From: Mike Dentzau <mikedentzau@aol.com>
Sent: Saturday, September 24, 2016 11:03 AM
To: Wilson, Matthew S.
Cc: matthewjaresco@gmail.com; dwilks@fountaininvestments.com
Subject: Nonuse Bank Modification
Attachments: Modification_9_24_16.pdf; Attachment A.pdf; Attachment B.pdf; Attachment C.pdf; Figure 4_revised_9_24_16.pdf; Figure 5_revised_9_24_16.pdf; Figure 5a.pdf; Figure 10_revised_9_24_16.pdf; Figure 13a.pdf

Nokuse Plantation Mitigation Bank

Re: Modification with Fee of Nokuse Plantation Mitigation Bank

ATTACHMENT A

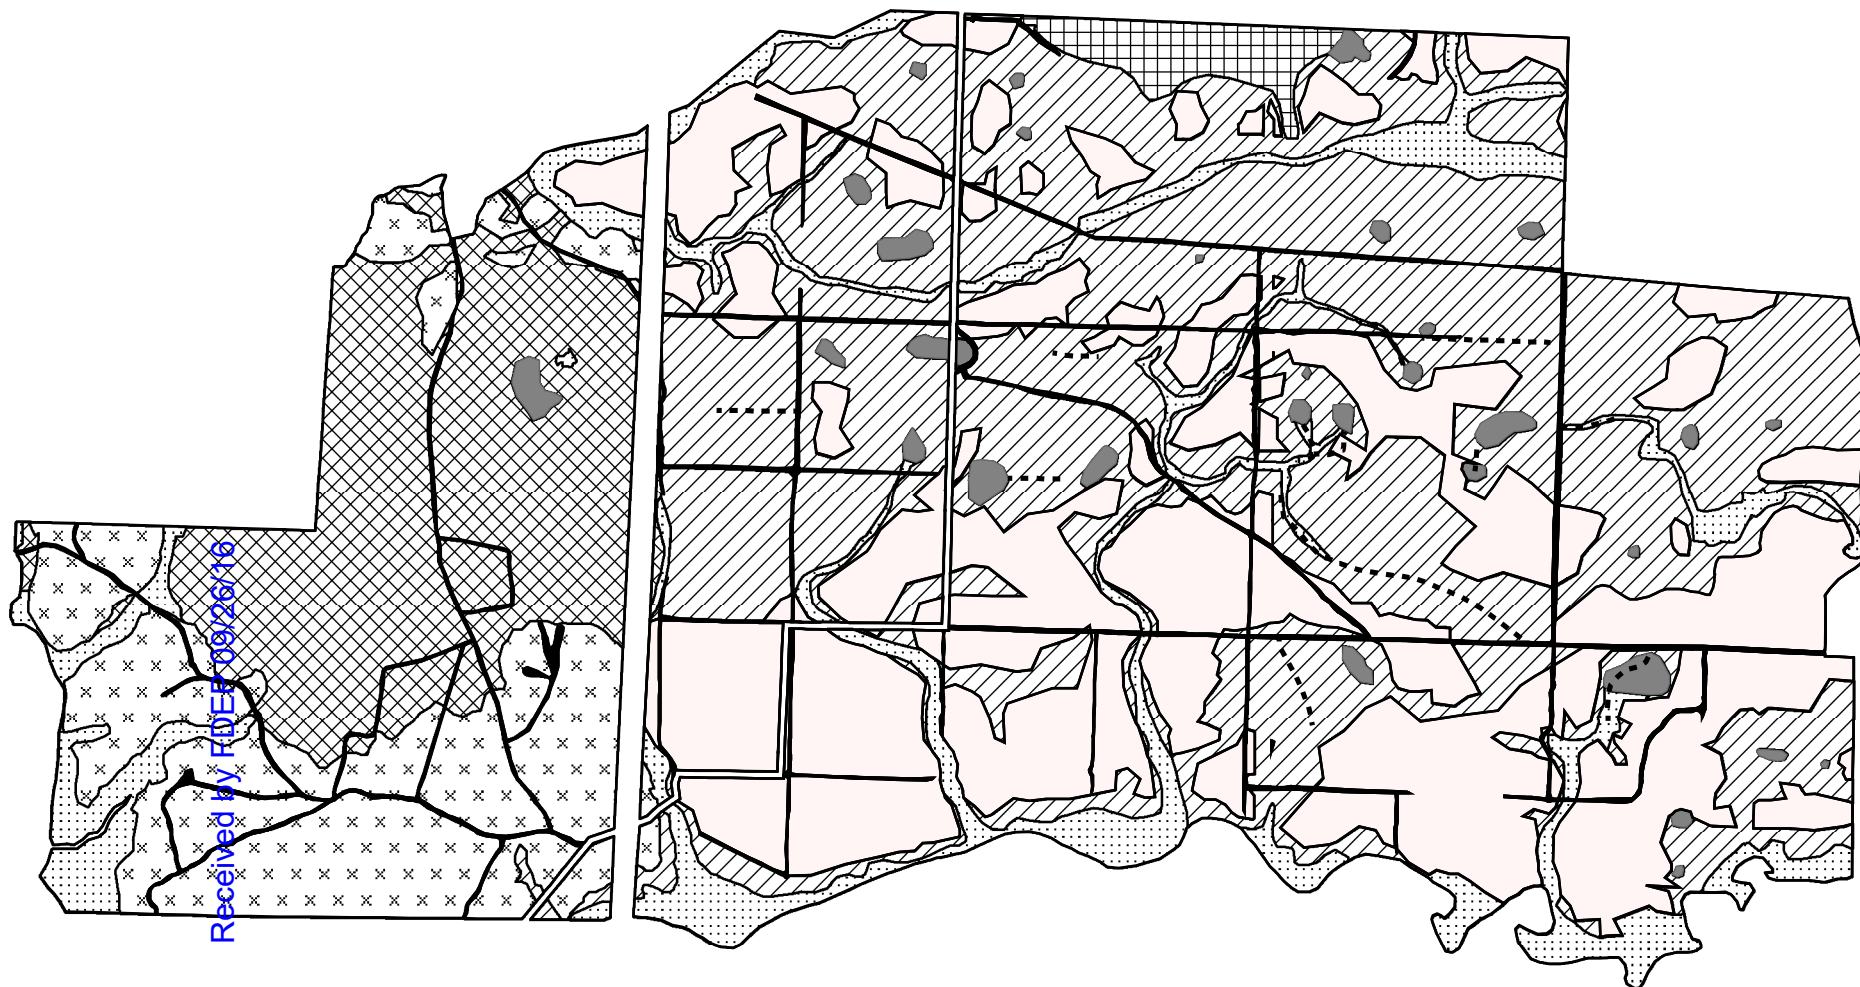
In an effort to determine an appropriate course of action and under what we felt was the latitude provided to the QMS, the bank initiated a pilot project during a period of *extreme low rainfall conditions*. **Attachment A** shows the location of the pilot project. In addition to cutting the vegetation the QMS used a bucket and blade to punch through the vegetation/soil berm and to spread the material into logging ruts and artificial depressions. **Attachment B** shows the conditions on site after the cutting and prior to the additional work described above. **Attachment C** shows the site conditions approximately 6 months after recontouring of the berm. All revegetation was natural and not augmented.

*10.a.5. Brush Reduction. Brush reduction will be completed within approximately 82 acres surrounding the Depressional Wetlands (gum swamps), to the greatest degree possible using a combination of mechanical cutting and hand cutting followed by herbicide treatment to retard regrowth. In addition, where possible and feasible without causing additional rutting, the Bank will either breach or otherwise lower organic berms surrounding the Depressional Wetlands to facilitate the movement of surface water and ground dwelling animals. The areas that are expected to benefit from this additional work are reflected in **Figure 5a**. This additional work needs to be completed during extremely dry conditions to minimize adverse impacts. This work should be completed prior to the second interim credit release, at the latest.*

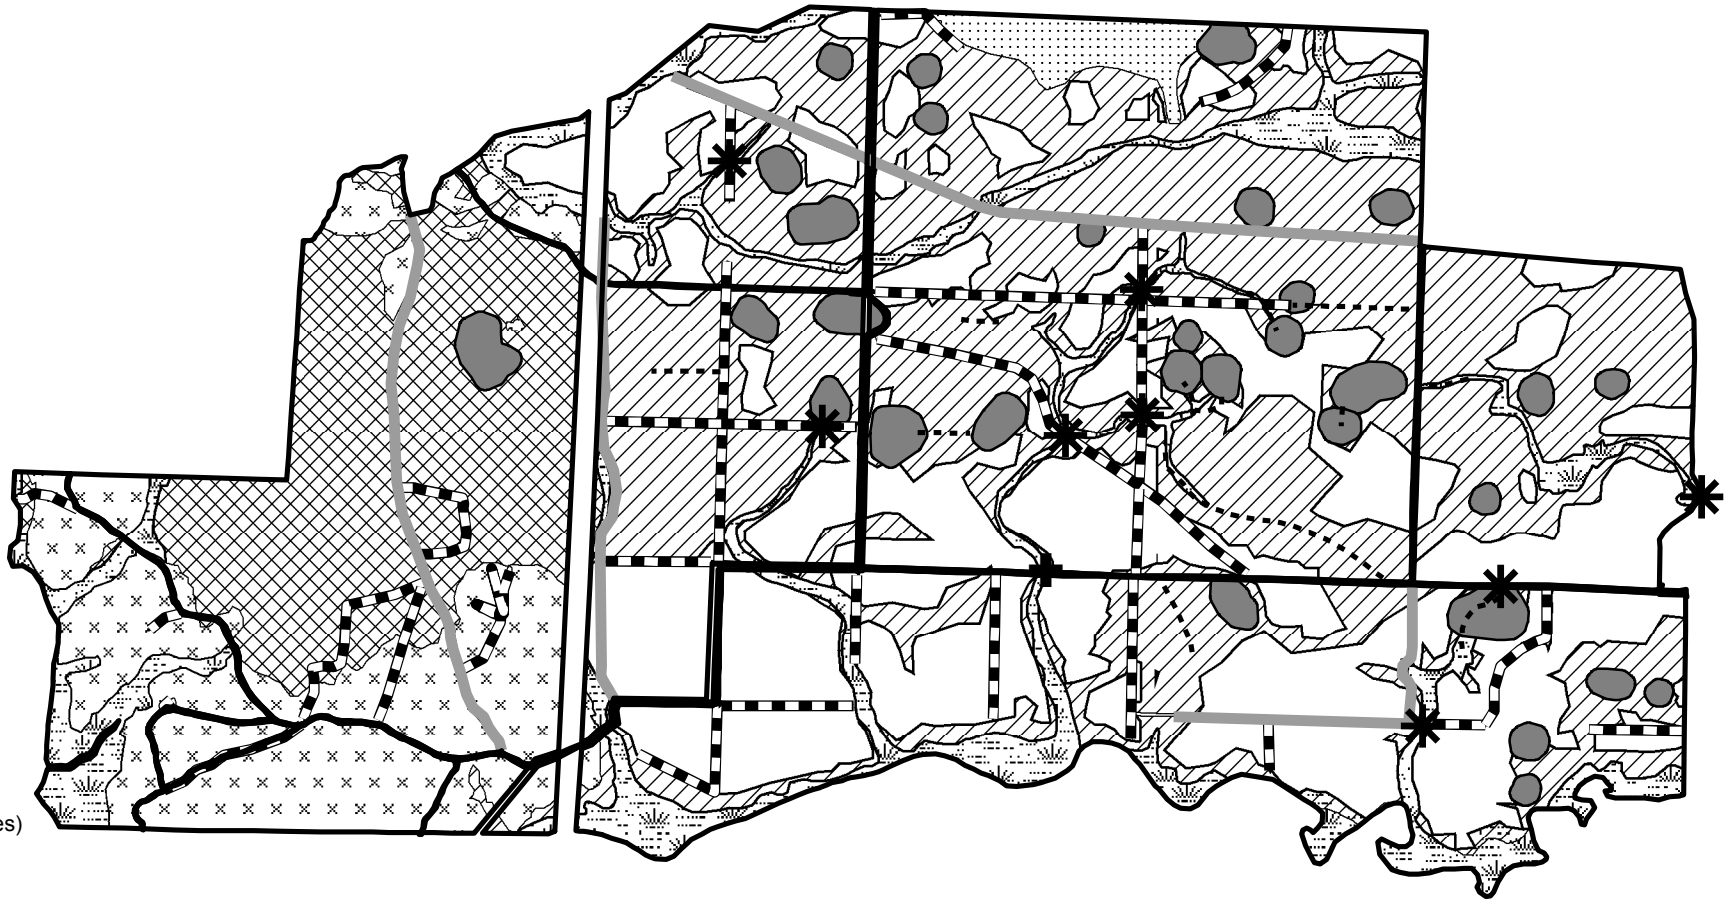
This requires the abandonment or removal of approximately 10 acres of roads. As you noted in your assessment, the intent of this has been complied with and some of these roads are now used as disked fire breaks. While you did observe some that driving had occurred on some of the roads, this access was for fire management and all roads associated with this condition are at grade and not impacting hydrology. Therefore, we believe we are in compliance with this condition. Figure 10 has been revised to show those roads remaining for fire management.

The permit required the removal of 6 road crossings. Detailed site review however has documented 12 areas where road culverts and some degree of restoration is appropriate. We request the condition be modified in the spirit of the following:

Required the installation of at least 9 ditch blocks. After pine removal and additional access to the site was possible, it was deemed appropriate that instead of blocks alone, some ditches would benefit from complete filling. We therefore request the condition be modified consistent with the following intent:

13.b. Twelve road crossings where the flow is currently impeded to various degrees will be restored by the removal of culverts or the installation of low water crossings flow (Figure 10). For culver removal, the road fill and the culverts will be excavated to attain adjacent natural grades, or when apparent, to native soils. For low water crossings, the culvert and fill material will be excavated to slightly below adjacent grades and the access point will be stabilized (Figure 13A). In either case, fill material shall be removed to an appropriate upland site and care will be taken to leave a surface area that has appropriate soils for colonization by native plants outside of any areas of rock, geotextile webbing or filter fabric required for the stability of the crossing.

13.c. A railroad boxcar bridge shall be installed at one stream crossing to maintain access with minimal impact on natural contours and vegetation (Figures 10 and 13).

d. Ditches that appear to have a negative impact on hydrology will be either blocked or filled using existing material onsite to match adjacent elevations as shown in Figure 10 and 14.

Figure 5a - Brush Reduction 5/2016

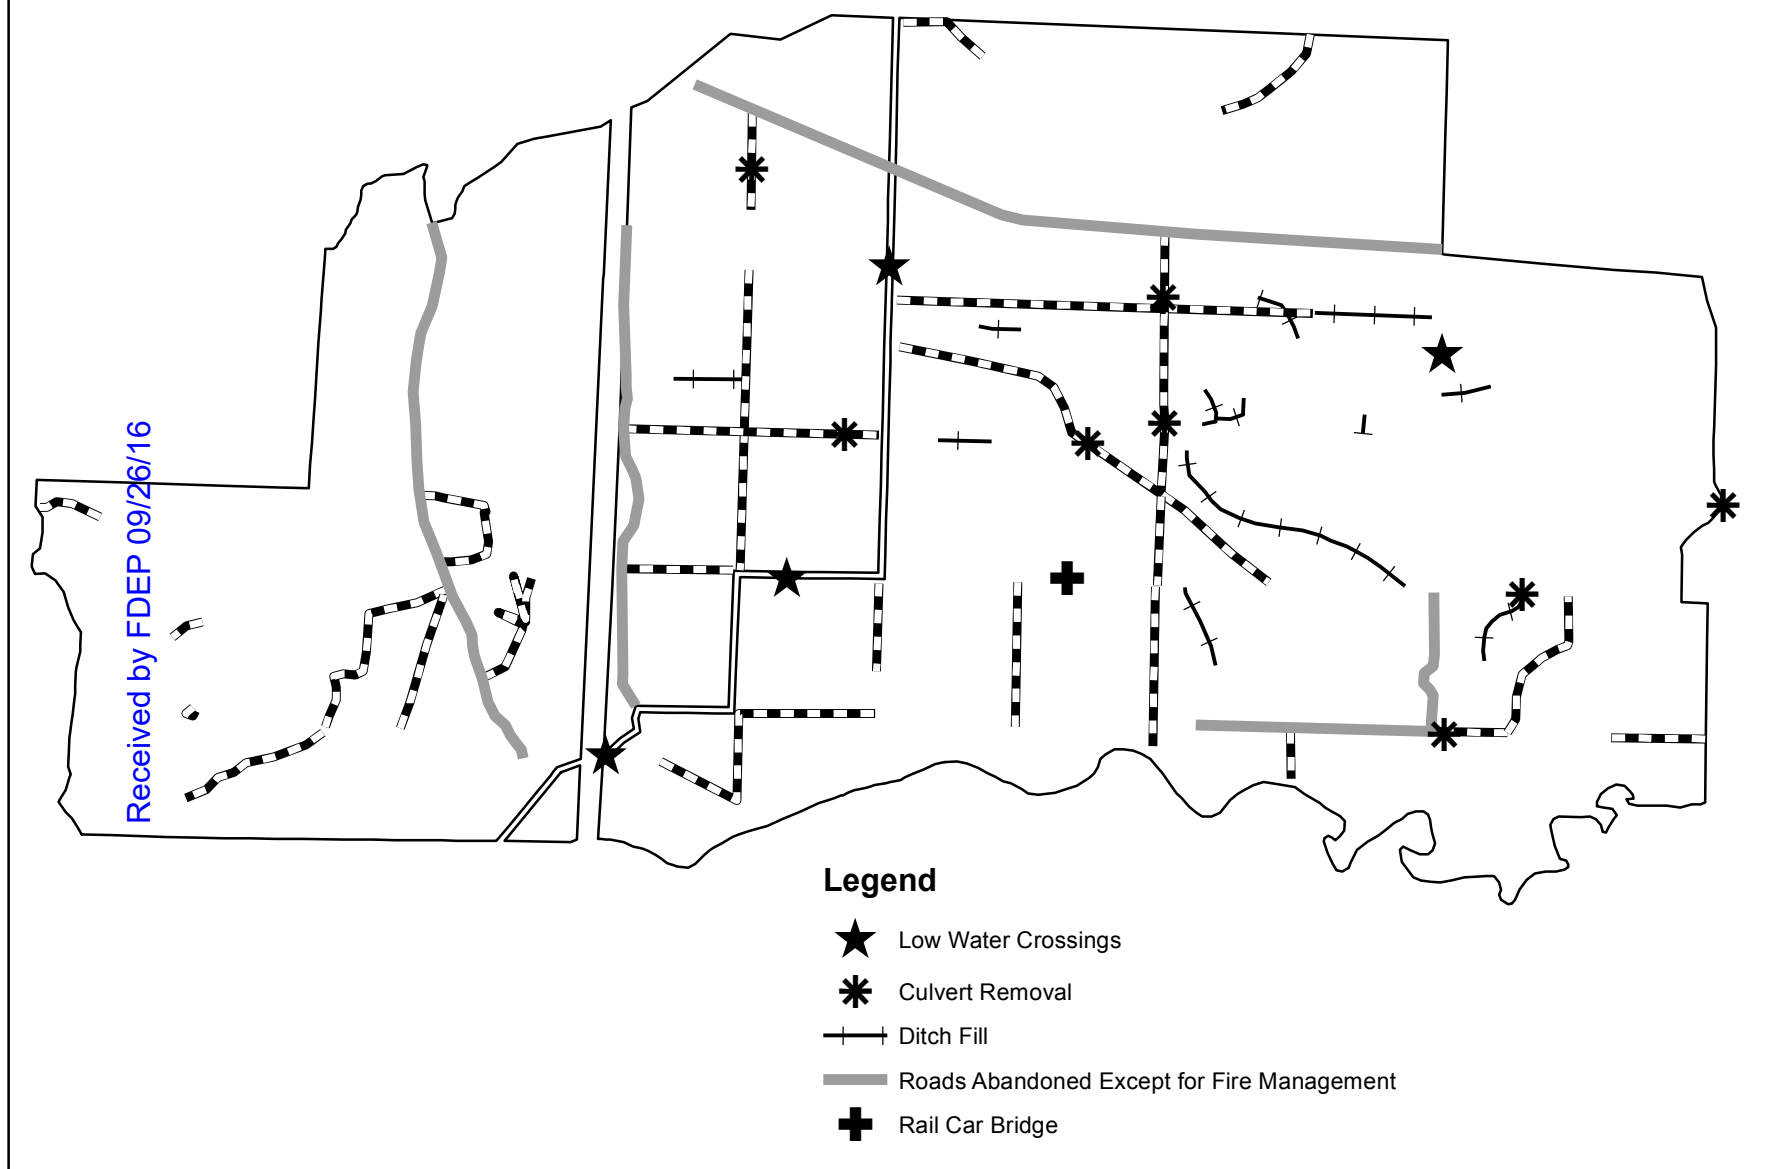
This condition requires the cutting of shrubs and slash pine in approximately 82 acres surrounding depressions gum wetlands. The intent of this was to improve the ability for long-term fire to modify the edges and improve herbaceous representation. This was to be completed mechanically.

However, as we accessed these areas we found that this shrubby zone was in most cases growing on an “organic debris berm”. After looking closely at these areas (which was only possible after pine reduction

and fire), it appears that previous silviculture practice involved pushing debris piles towards the wetland depressions. As a result, cutting of the vegetation and prescribed fire are not enough to restore the transitional zone. Furthermore, and more importantly, this organic berm substantially impacts hydrology and the ability of amphibians to use the wetlands for breeding.
